PARTS SERVICE BULLETIN

No G.A. 8X."A" Group Models.Engine Steady.

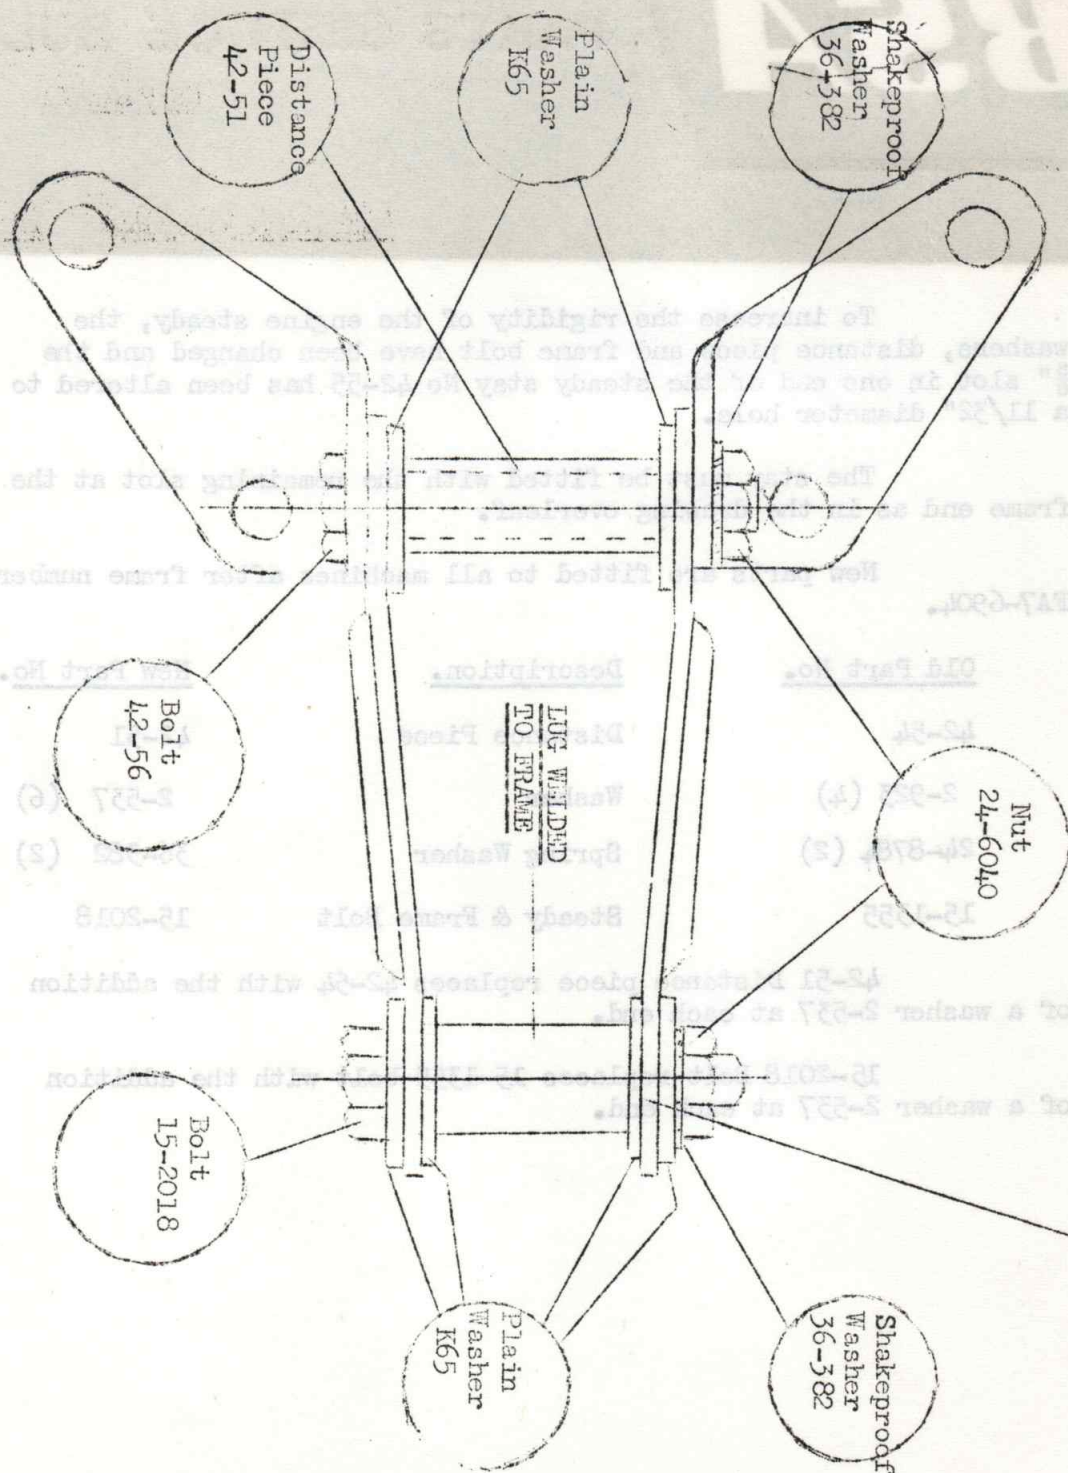
To increase the rigidity of the engine steady, the washers, distance piece and frame bolt have been changed and the $\frac{5}{8}$ " slot in one end of the steady stay No 42-55 has been altered to a $1\frac{1}{32}$ " diameter hole.

The stay must be fitted with the remaining slot at the frame end as in the drawing overleaf.

SLOT END OF STEADY
TO BE AT FRAME END

42-51 Distance piece replaces 42-54 with the addition of a washer 2-537 at each end.

15-2018 Bolt replaces 15-1355 bolt with the addition of a washer 2-537 at each end.
